Moldova Roads Rehabilitation V

NATIONAL ROAD ADMINISTRATION

CLARIFICATION DOCUMENT No.3

Rehabilitation of M1 – Leuşeni - Chişinau Road:

8. For the articles 50103.1 – 50103.3 „Construction of culvert inlets and outlets in concrete to pipe culverts” the measurement unit is expressed in pieces:

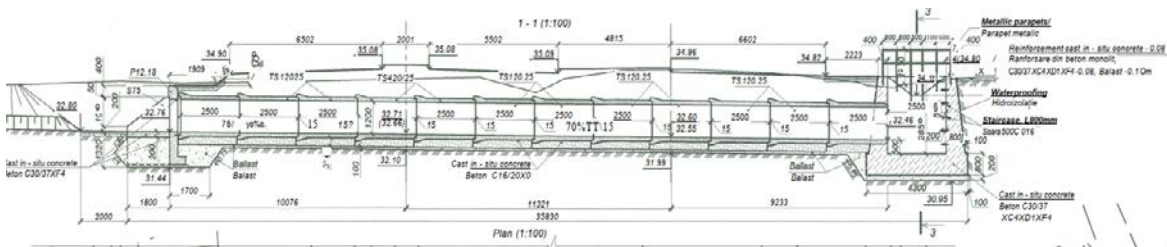
Upon reviewing the documentation, we notified that the values for the quantities appear to correspond to the values of headwalls (inlets/outlets) rather than the values of the pipe culverts.

However, for item 50103.3 "Pipe culverts Ø1500 mm," the indicated quantity is 7 units, whereas the drawing shows 5 headwalls.

Please clarify whether these quantities represent the number of headwalls and wingwalls or the number of culverts. Additionally, please clarify the quantity of inlet/outlet elements for "Pipe culverts Ø1500 mm."

Additionally, for the Ø1200 mm culvert, please specify where the drop chamber (camera de cadere) is to be included in the offer:

Please note that the quantities under Items 50103.1–50103.3 represent complete inlet/outlet structures to pipe culverts, measured in pieces, and not the number of culverts. Each piece comprises the relevant portal/headwall, wing walls and associated structural components shown on the Drawings.

For Item 50103.3 – Ø1500 mm, the correct design quantity is 7 Pcs: PC 32+44.14 – 1 Pc; PC 65+41.6 – 2 Pcs; PC 78+80 – 2 Pcs and temporary bypass road at PC 36+90 – 2 Pcs.

The drop chamber associated with the Ø1200 mm culvert at PC 0+59.44 is measured separately under Item 50503 and shall not be included under Item 50103.

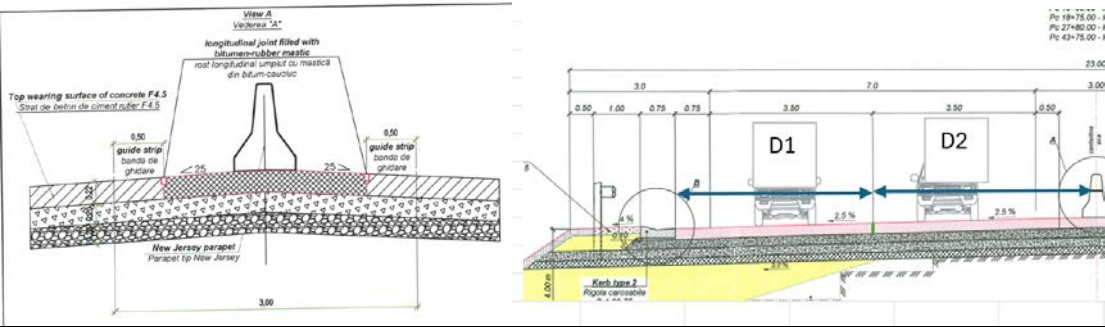
Please confirm whether the indicated lengths represent only the length of the pipe/culvert, excluding the wingwalls, given that these appear to be quoted separately under items 50103.1 – 50103.3.

Furthermore, regarding the Ø1500 mm pipe culvert, our verification indicates a total length of 36.3 m, compared to 58 linear meters. Please clarify which one is the correct quantity.

Please be informed that the quantity of 58 linear metres for Ø1500 mm pipe culverts is confirmed.

It comprises 35 linear metres of the new Ø1500 mm culvert at PC 78+80 and 23 linear metres of Ø1500 mm pipe culvert provided for the temporary bypass road at PC 36+90.

Accordingly, the approximately 36.3 m identified by the Participant relates only to the permanent culvert at PC 78+80 and does not represent the total quantity included in the BOQ.

The culvert barrel length is measured separately from the inlet/outlet structures, which are measured under the respective items in pieces.
